TOWN OF VERNON
Planning & Zoning Commission (PZC)
Virtual Meeting Notice & Agenda
Thursday, February 4, 2021, 7:30 PM

SUBJECT: PZ 2021-01, 1129 Hartford Tpke.

An Application **[PZ-2021-01]** has been submitted by Chapman Acres, LLC, for a Site Plan of Development to replace an exiting 3,600 s.f. maintenance building with a 6,650 s.f. maintenance building, including demolition and associated site work at the Mt. Vernon Apartments, 1129 Hartford Tpke. (Assessor ID: Map 43, Block 68, Parcel 22A).

Maintenance Building
Mt. Vernon Apartments
Chapman Acres LLC
1120 Hartford Turnpike, Vernon, Connecticut
Assessor's ID# 43-0068-0022A Zone: PRD

DATE
1-15-2021
SCALE
1"=20'
JOB NUMBER
2020-055
SHEET
1 of 1

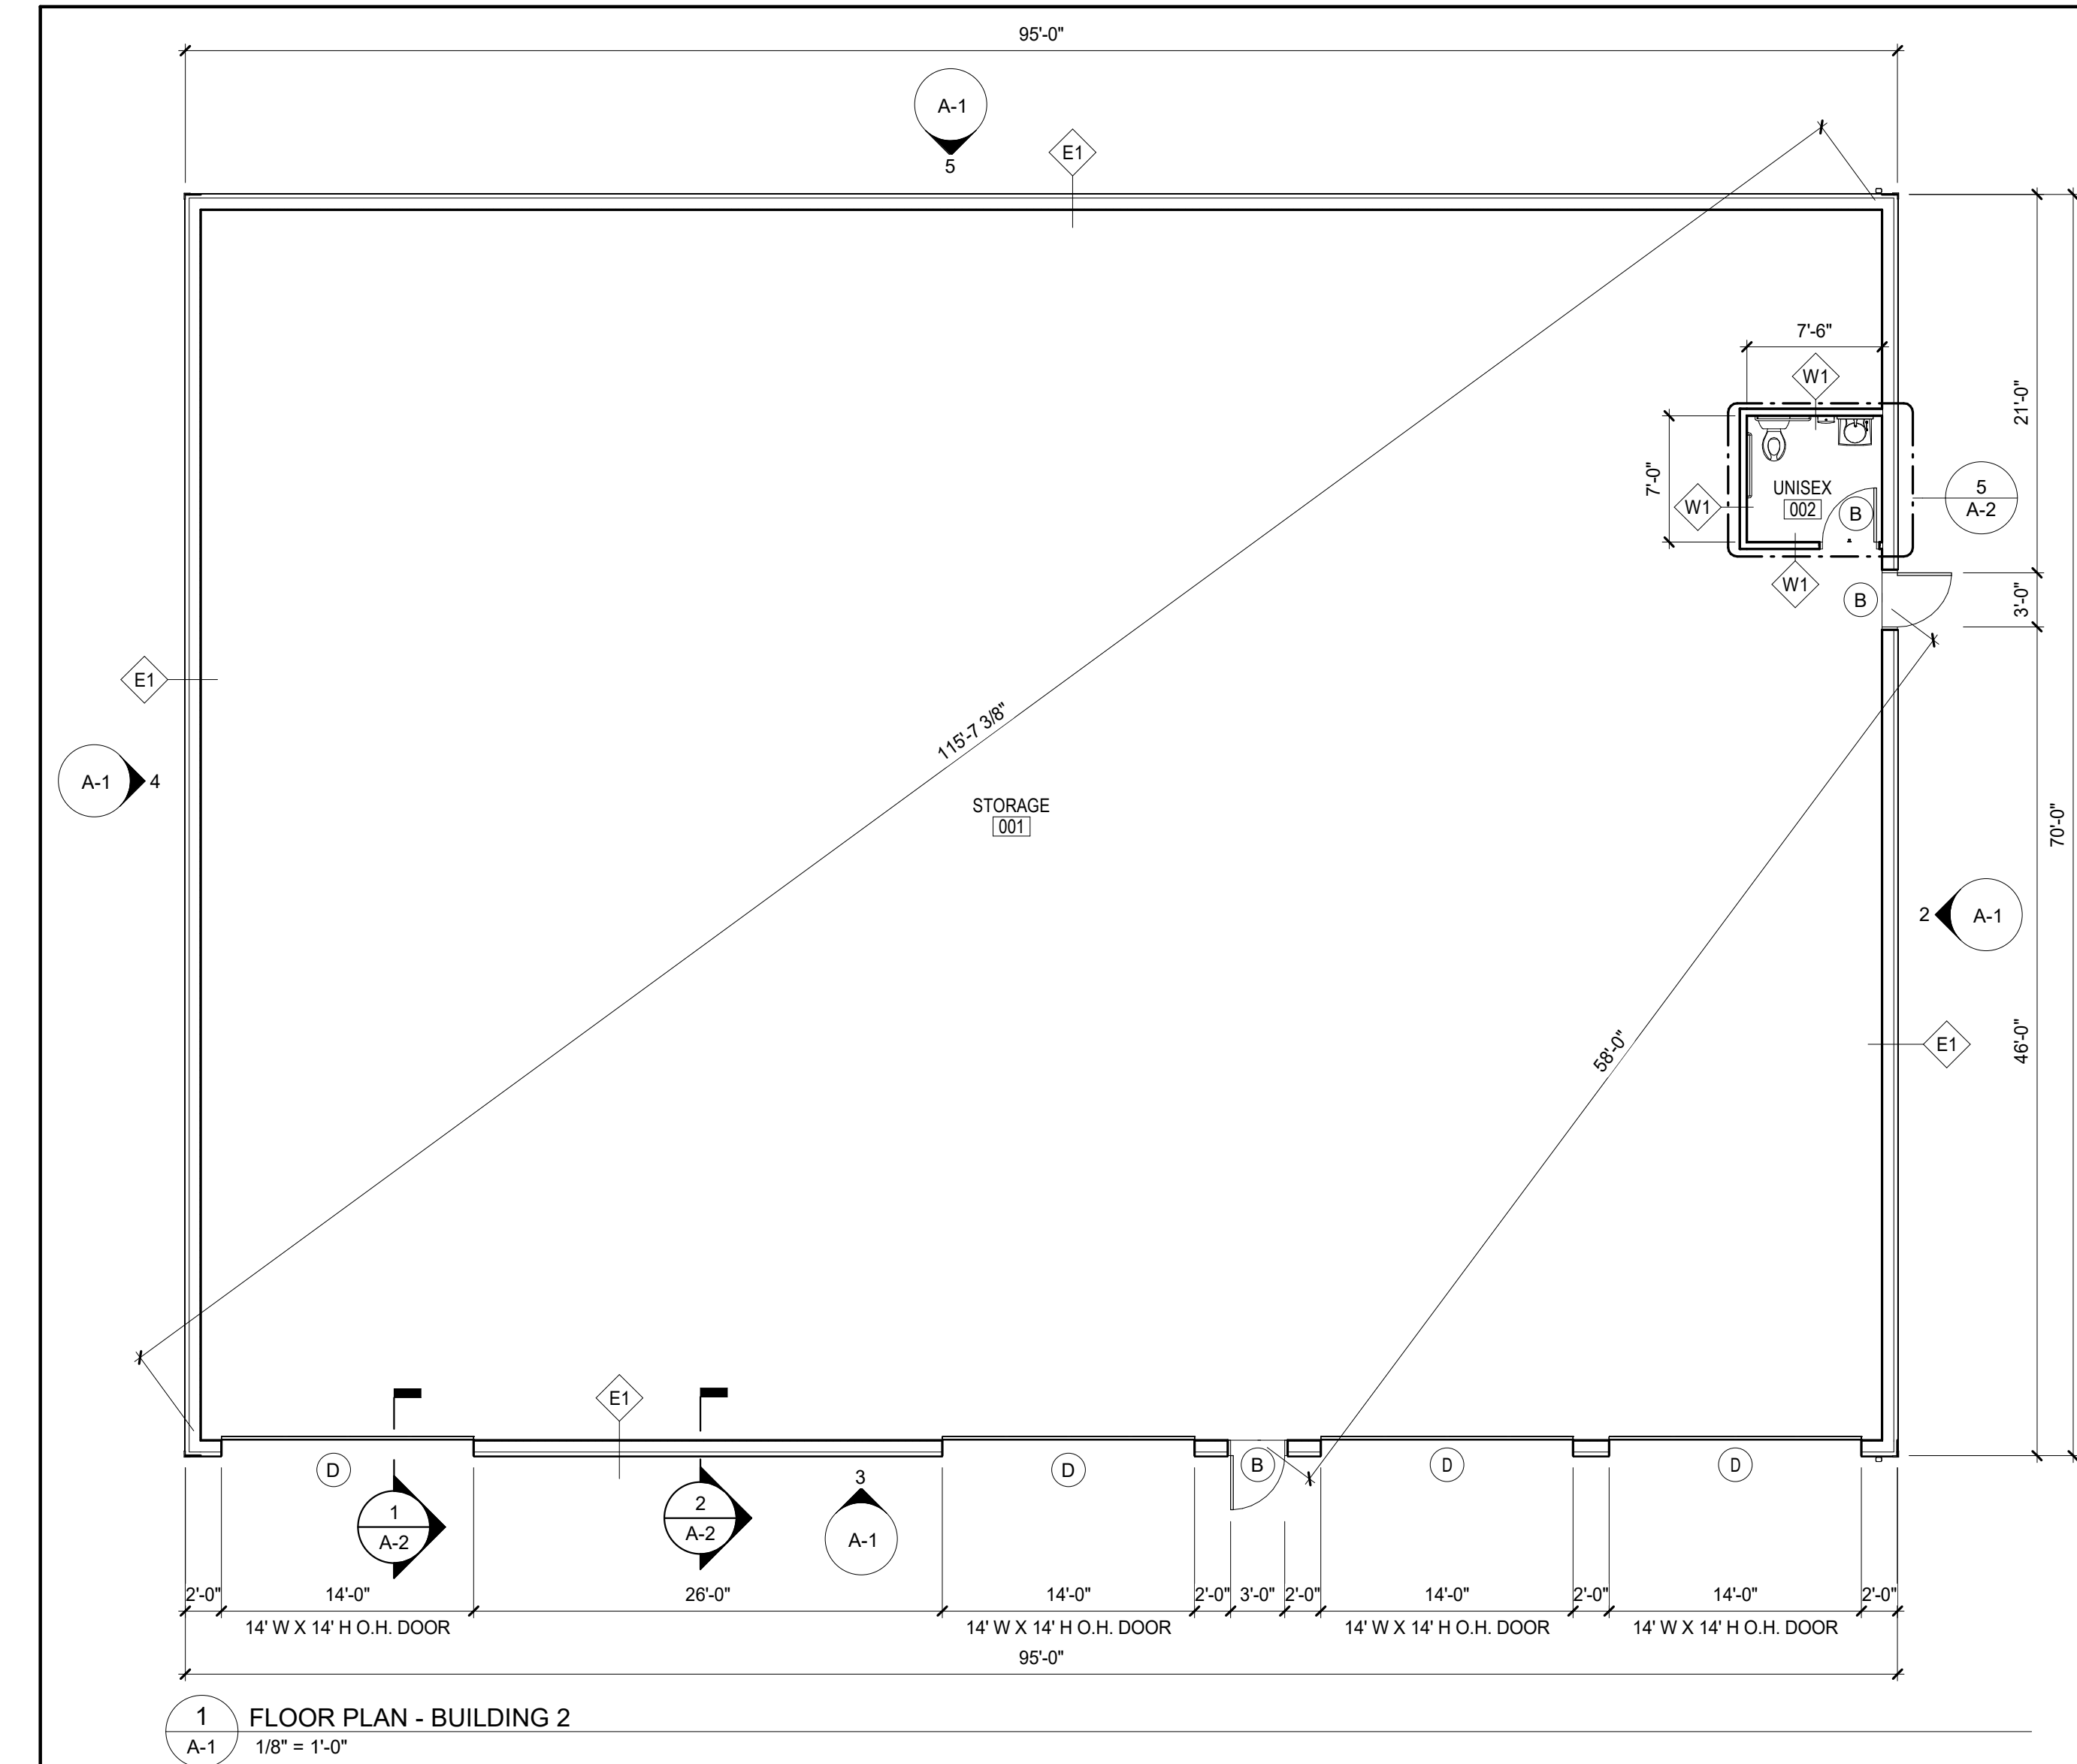
I have reviewed the site plan, LID Checklist and Drainage calculations and the project appears to meet our objective to not increase stormwater runoff resulting in off-site impacts. I believe that some type of siltation barrier along the north and east limit of disturbance and a recommended seeding schedule as part of the short term and long term stabilization program should be included on the plan.

My final, very minor comment – we should have some specification of the size of the trees proposed for the screen along the easterly line. Arborvitae grows pretty quickly, but this new building is considerably larger than the current one, so something in the 4 to 6' height range might appropriate and provide a function screen within a few years. 2 gallon container plants from the big box retailer will not be effective for many, many years. Just a suggestion.

I would ask you to consider placing all or at least portions as it is visible from the neighboring property

Is the perimeter fence owned by the Applicant?

Its in pretty bad condition; is there a plan to erect a new one (at least adjacent to the apartment complex to the east?)

I have revised the attached Site Plan to address the comments received thus far. Revisions include:

- Add a call-out to "repair the existing chain link fence east of the building as necessary"
- Note the size of the arborvitae to be 4'-6'. However, after further research and determining that these trees grow 3-5' per year and can have a 15'-20' spread, I increased the spacing from 6' to 8'.
- A silt sock sediment barrier has been added to the north and east of the area of disturbance, and a detail added to the plan.
- The call out for loam and seed has been revised to identify the seed as a turf mix and specify the dates for seeding.

The fence does belong to the applicant. However, there are not plans to replace it. We are proposing a line of arborvitae adjacent to the apartment complex along the fence which should break it up some.
